STAFF RECOMMENDATION

NCPC File No. 6913

NATIONAL NAVAL MEDICAL CENTER CONNECTORS AND COURTYARDS

March 26, 2009

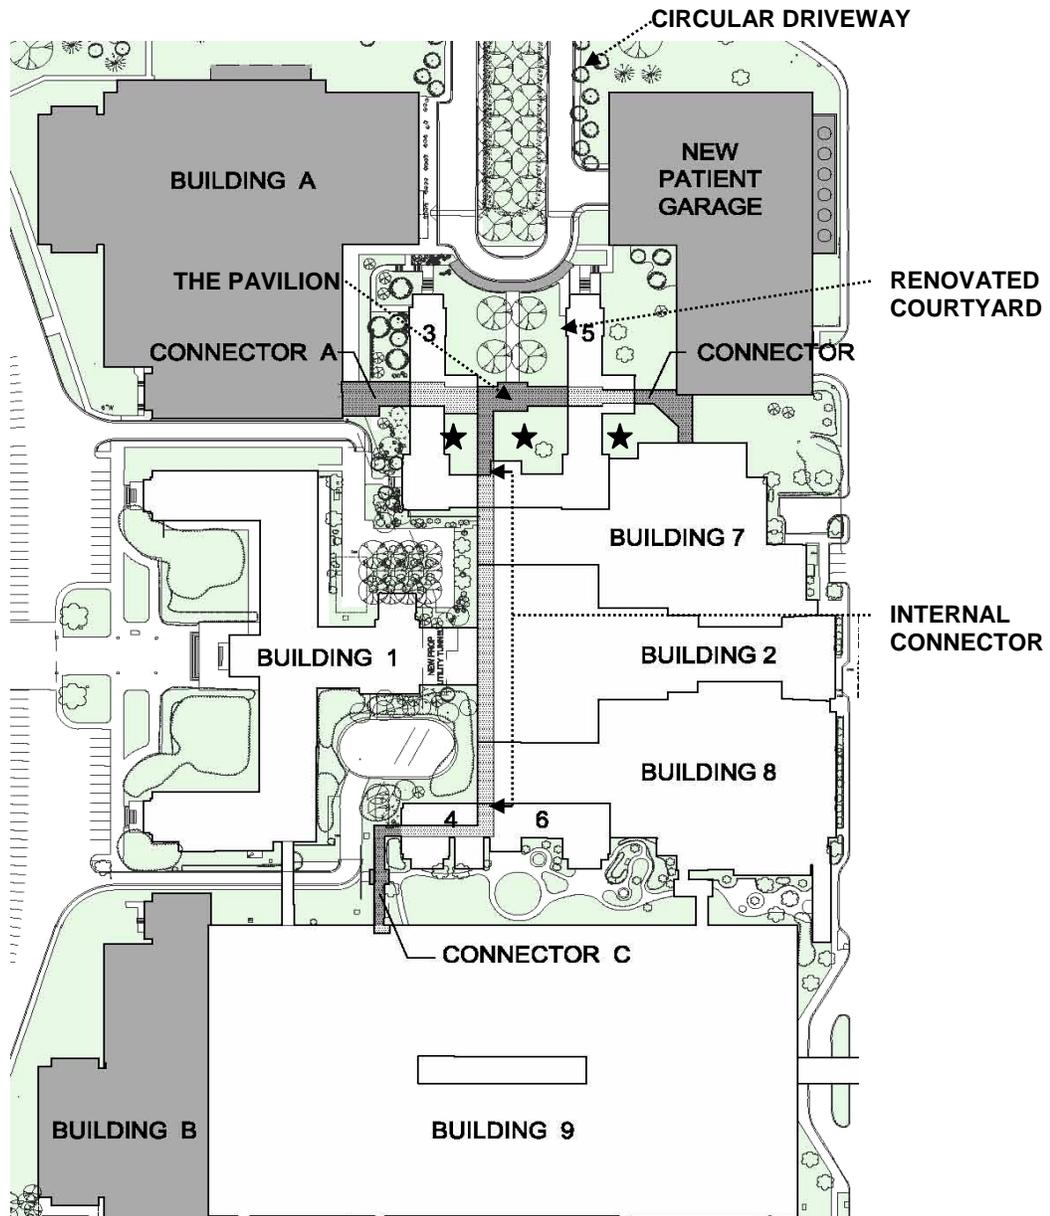
In response to the Commission's previous action, the Navy has submitted a more detailed site and landscape plan for the exterior courtyard between Buildings 3 and 5 and the circular driveway. Staff finds the landscape plan suitable for the proposed space given its main function as a patient pick-up and drop-off area. The Willow Oaks and Rhododendrons in the center island will provide a colorful and largely maintenance-free landscape. The area between Buildings 3 and 5 has been neatly simplified to include grass cover and a row of Oak trees and benches that will frame the walkway to the Pavilion.

Originally staff was concerned that too much of the area was dedicated to the driveway; however, the more detailed plan shows that the driveway is 24' wide which is necessary for two vehicular lanes – one to continue around the circle and the other to pull over to the loading zone. The loading zone is adequately sized (approximately eight cars long) to accommodate several vehicles with disabled patients. The Navy has added continuous sidewalks and crosswalks from North Palmer Road to Building A, the parking garage, and the Pavilion entrance. They have also added a continuous sidewalk in front of the parking garage, and a sheltered area and benches in front of the loading zone at Building A.

The Navy has submitted a landscape plan for the interior courtyards. Originally, they thought the courtyards would be publically accessible with benches and tables; however; upon further consideration, they determined that the small size and dark nature of the spaces would not be conducive to public use. Instead, the Navy has proposed to plant a vegetative groundcover that will thrive in the shade. Staff finds that the living vegetation will be visually appealing for those walking through the connectors and will also help to manage stormwater.
